Strategic Planning and Development Policy Committee

AGENDA

Tuesday 25 February 2020

Subject: **SEACLIFF PARK RESIDENTIAL AND CENTRE DEVELOPMENT PLAN
AMENDMENT**

General Neighbourhood Zone

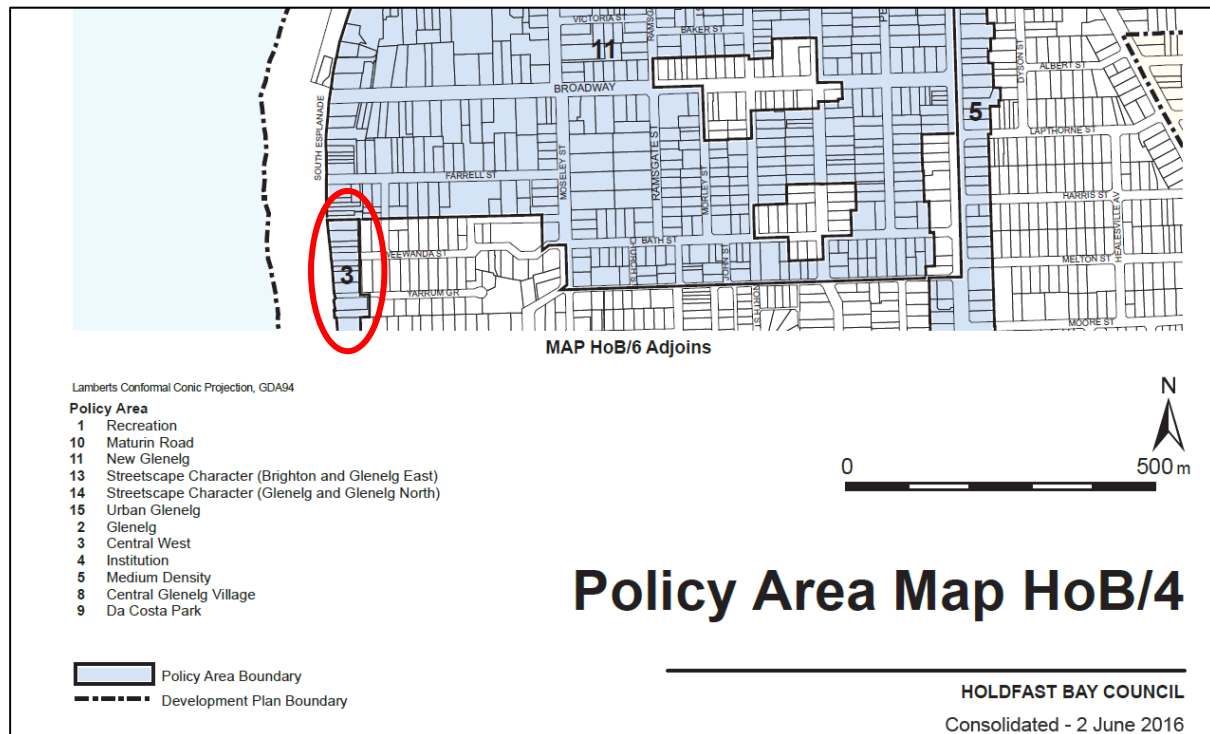
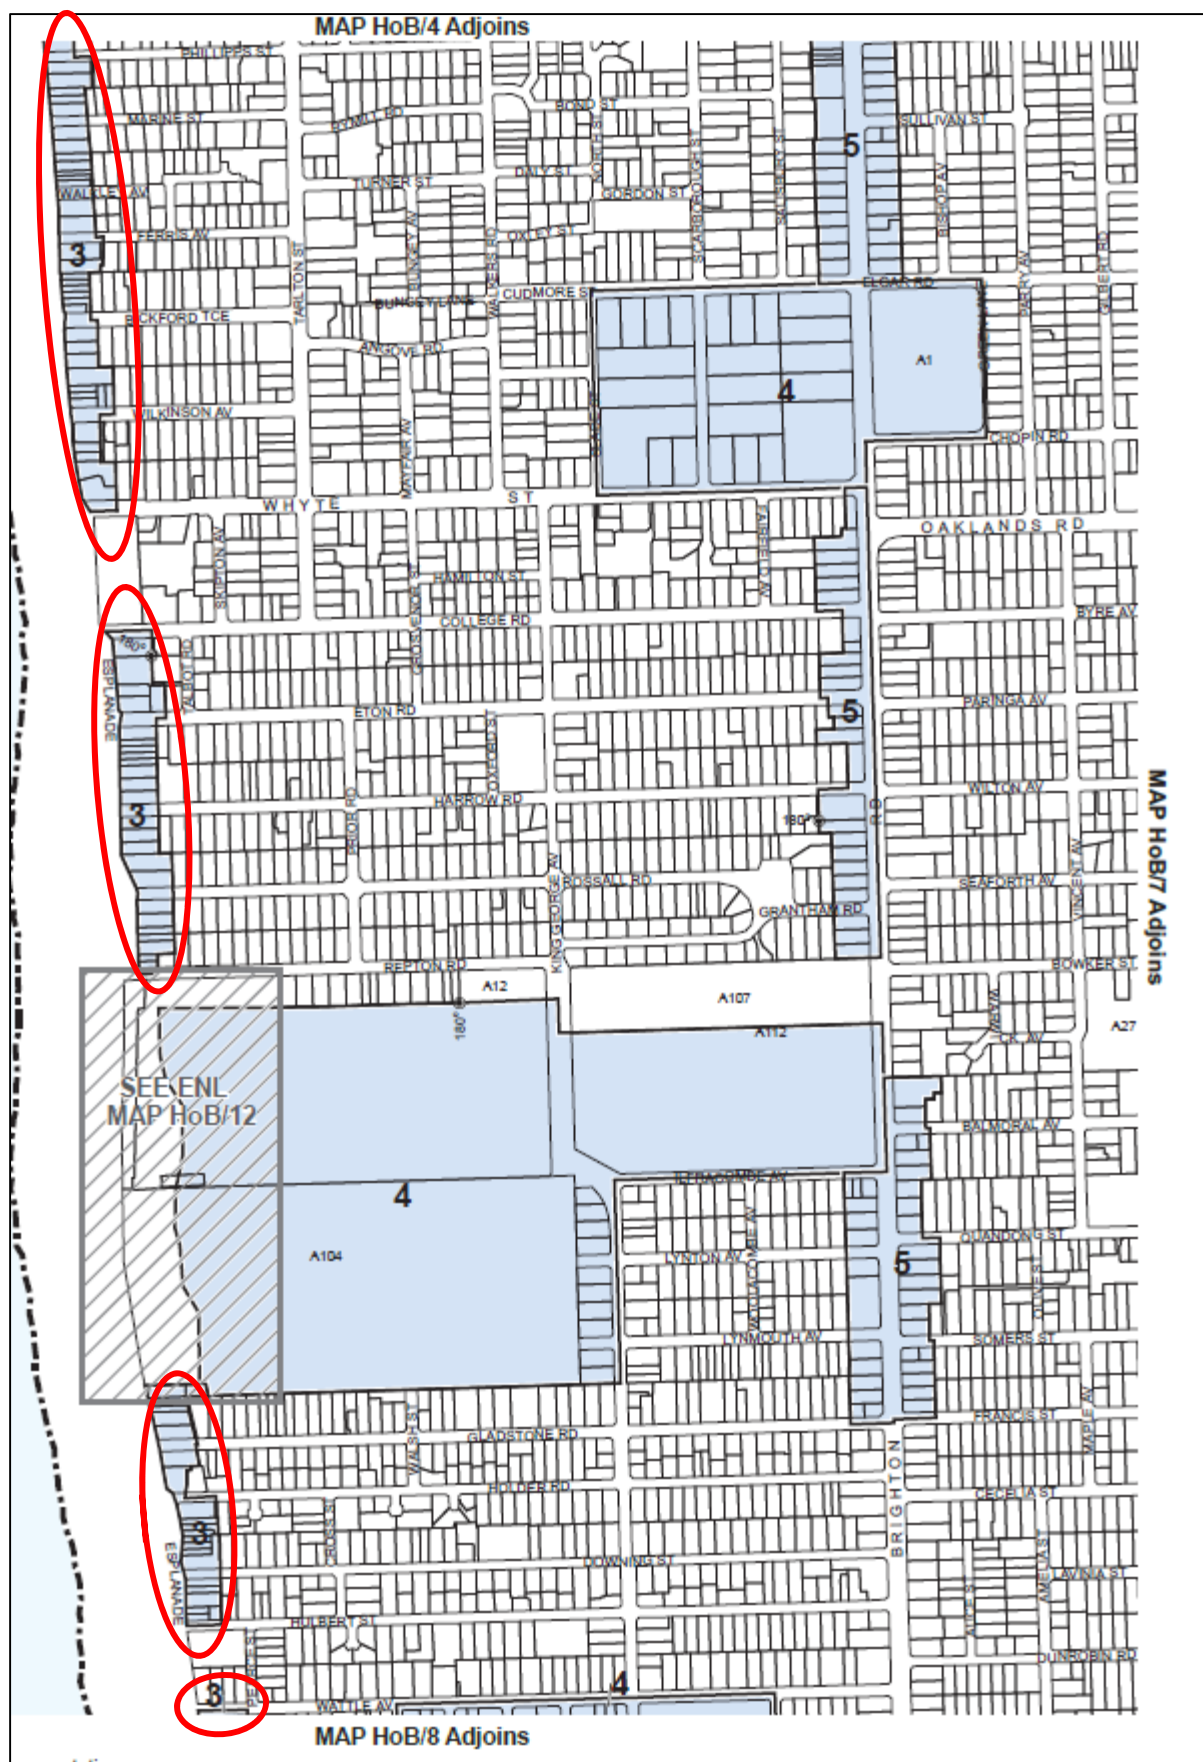
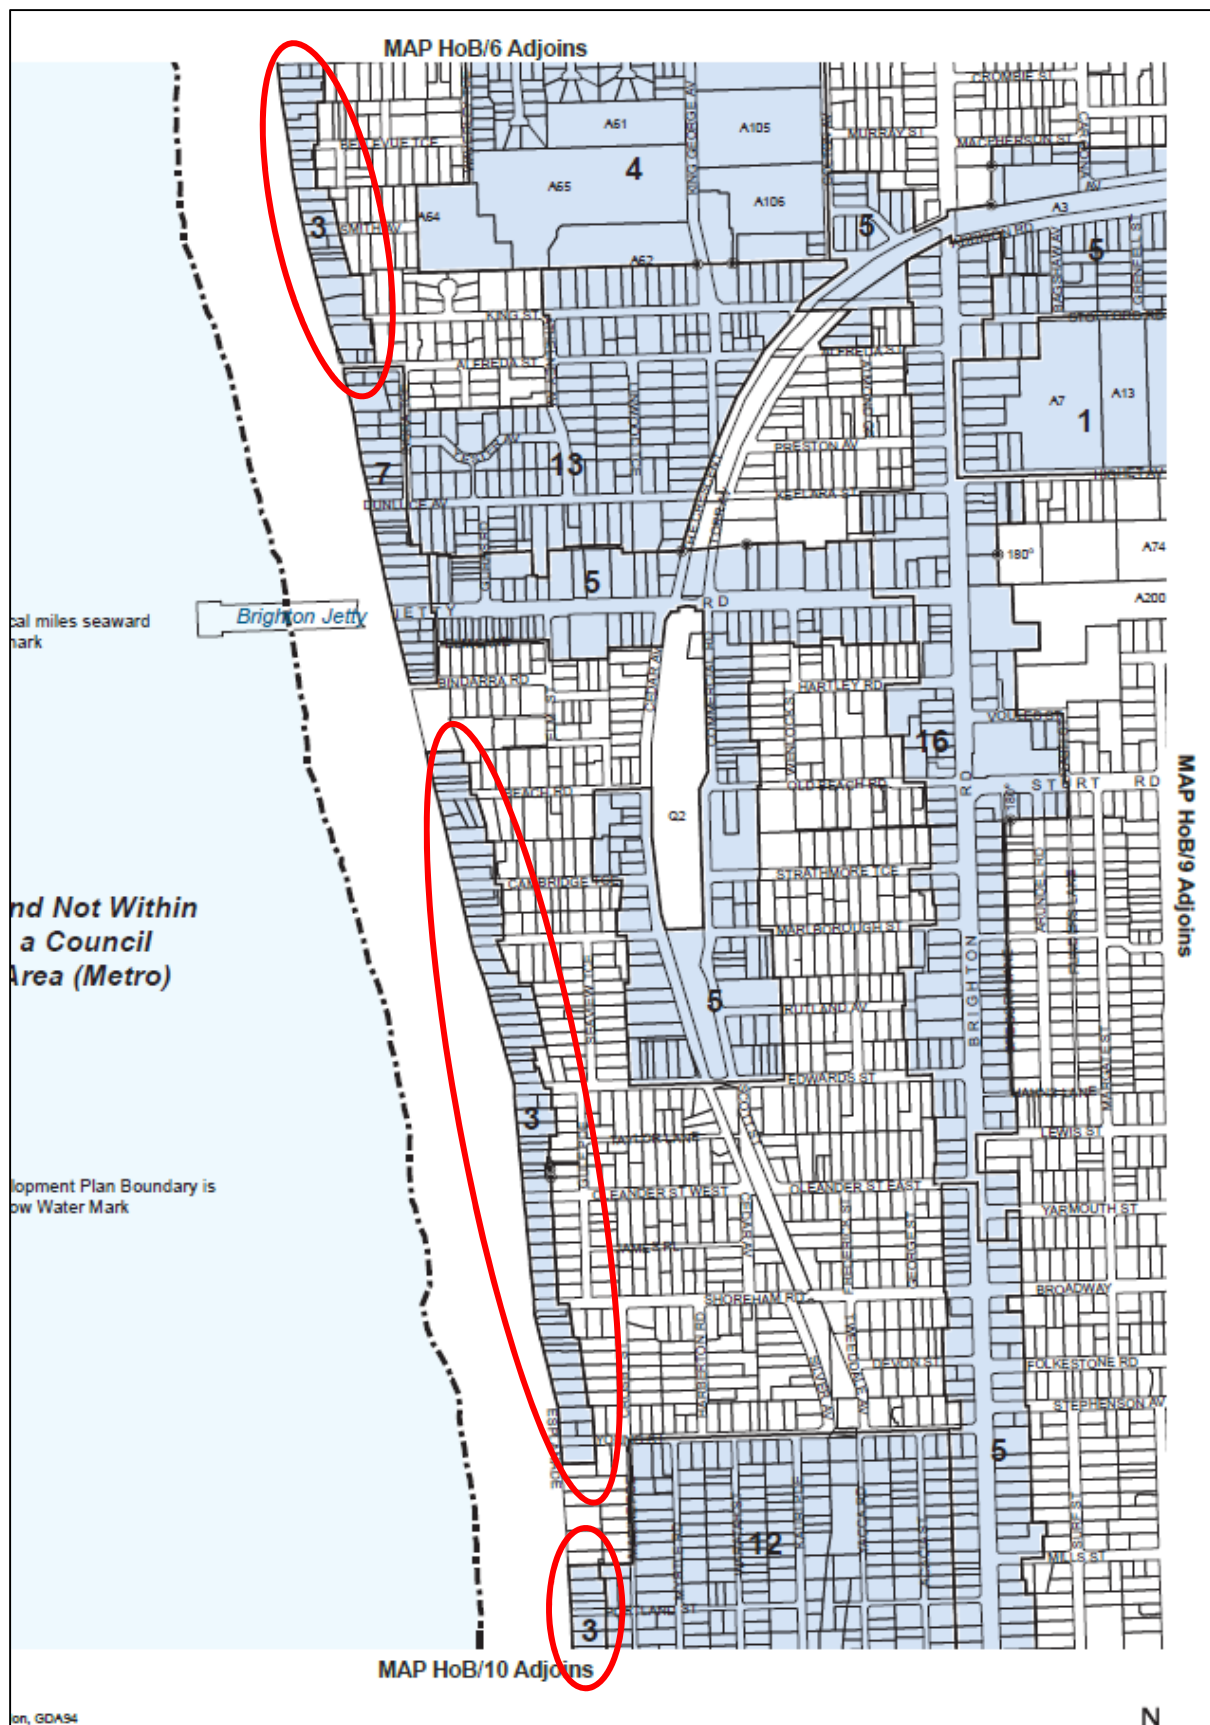
The General Neighbourhood will replace nearly all of the existing Residential Zone with the exception of a small portion around North Esplanade. Council has no objection to the proposed spatial layout of the General Neighbourhood Zone.

The land division requirements for the General Neighbourhood Zone are a significant departure from the Residential Zones within the City of Holdfast Bay. No detailed analysis has been provided for this substantial reduction in allotment sizes or the impacts it will have. The requirements have been reduced by 25% for both the frontage and allotment sizes, which will significantly impact on densities, but with no analysis of the impact on infrastructure such as stormwater, on-street parking or capacity at zoned schools. If Council were to propose such a significant policy change in a Development Plan Amendment, substantial research would be required to justify the new Policy.

Council requests a detailed analysis of the impact this increase in density with have on the local infrastructure.

The Esplanade south of the Broadway Glenelg South is currently Zoned Residential, Policy Area 3, which allows for dwellings up to 3 storey in height, minimum frontages of 5 metres, and allotment sizes ranging from 200sqm to 300sqm. The area is proposed to be zoned General Neighbourhood and only allows for two storey dwellings on allotment frontages ranging from 9 metres to 12 metres. This does not keep the same policy requirements and will place new development at odds with previous development.

Suburban Activity Centre Zone

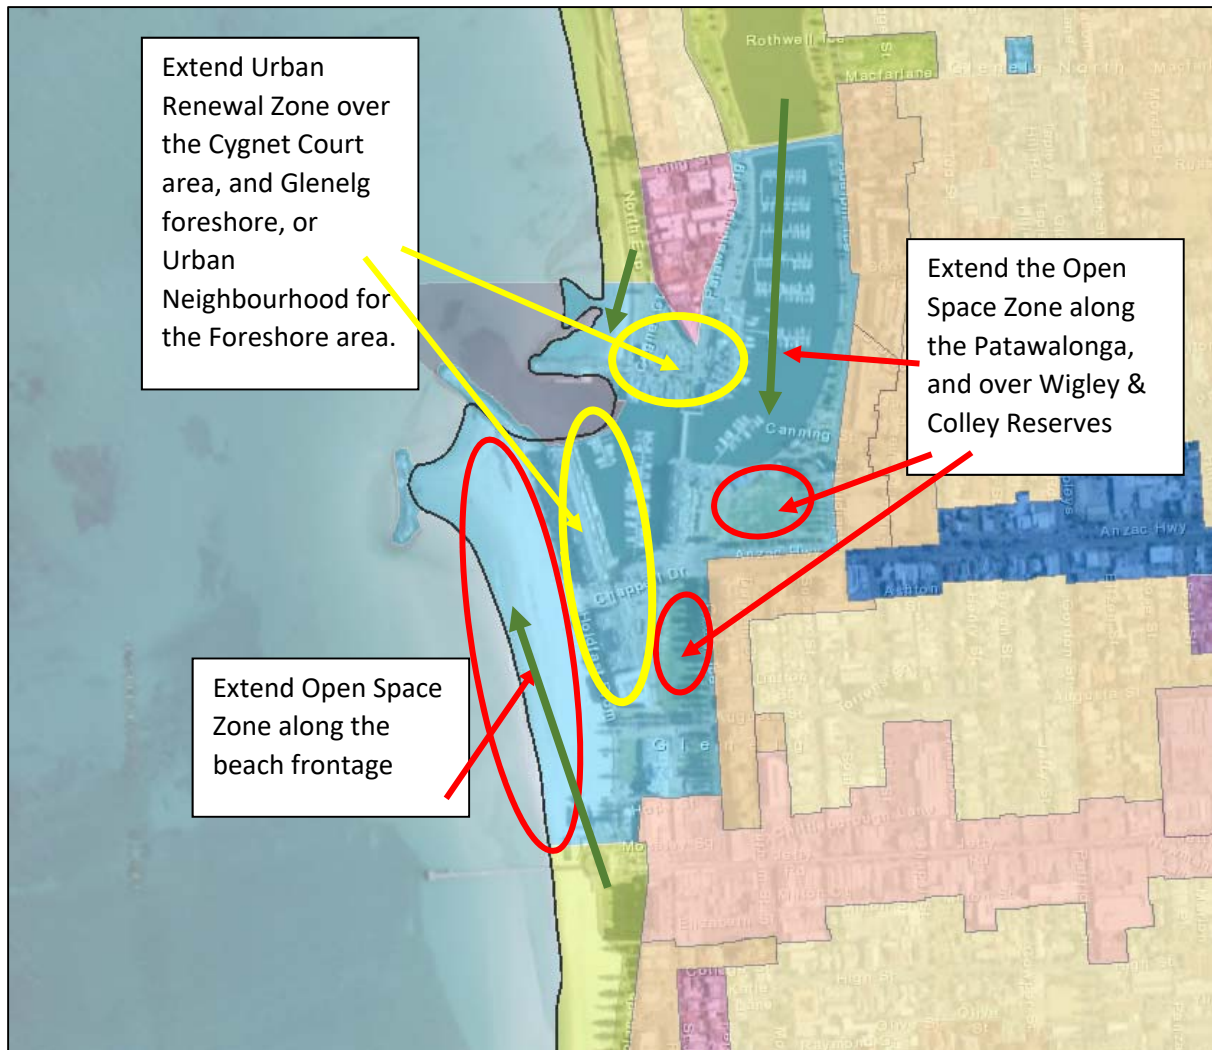
The existing Glenelg Foreshore and Patawalonga Area is to be zoned Suburban Activity Centres Zone. This Policy not consistent with current tourism and residential focus, especially area on the northern side of the marina where is entirely residential, upper market. Given the existing name of the zone, the Policy Content within the Development Plan has a lot of local contain and is unique to this area.

In theory a Bunnings warehouse could be developed in the Cygnet Court area, which would be completely at odds with the existing area that is entirely residential. The Cygnet Court area which is entirely residential, will be at odds with the Proposed Policy that seeks residential development only in conjunction with non-residential development, however this is an entirely residential area and any commercial development would be at odds with existing character and impact on the amenity of the area.

Design in Urban Areas

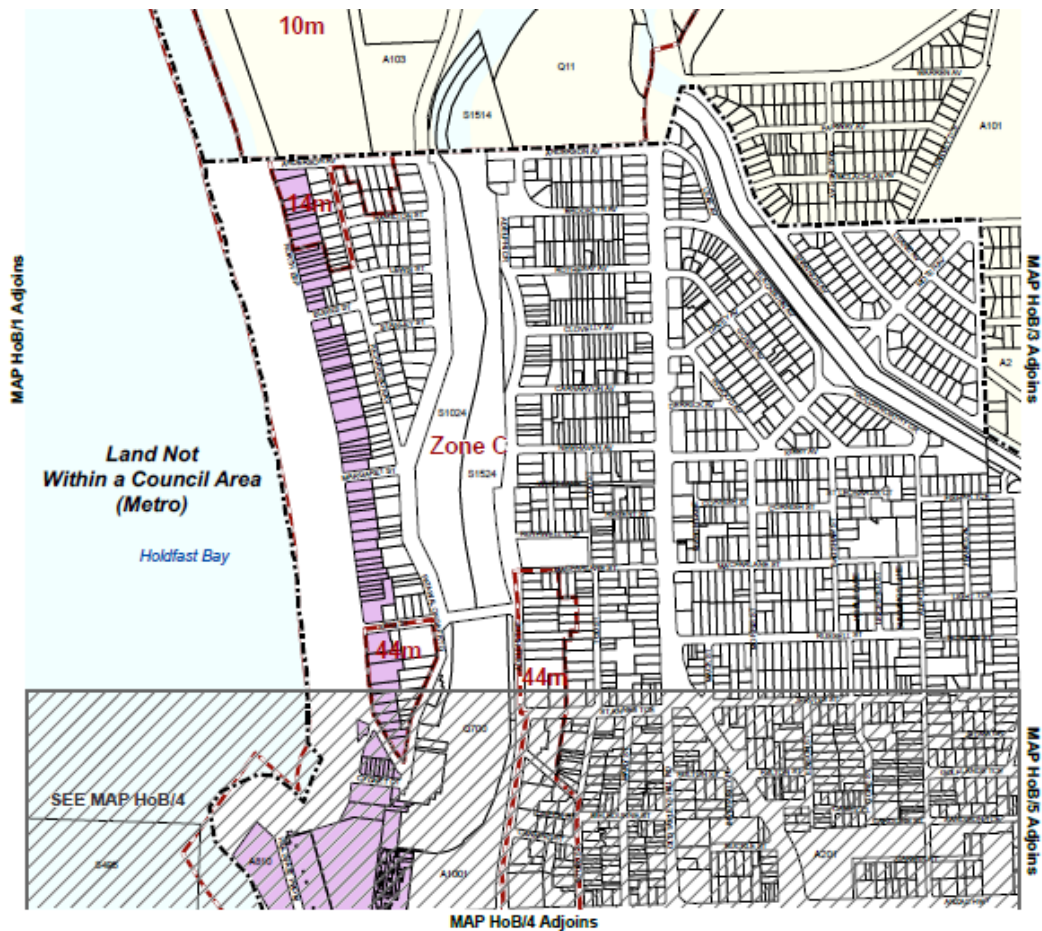
Ancillary development Principles 16.1, though probably meant to the 17.1, should state that garages and carports should be setback 0.5 metres behind the main face of the dwelling. The requirement for a carport or garage to be set back 5.5 metres from the street is not carried over into the Zone provisions, which it should be. Otherwise a garage under a main roof can be setback 3 metres (for DTS) in a Housing Diversity Zone. This could potentially be set even close if dwelling setback is considered acceptable in a performance assessment application.

Council recommends that garage setback provisions are included in the assessment of a dwelling, not just for a separate ancillary outbuildings.
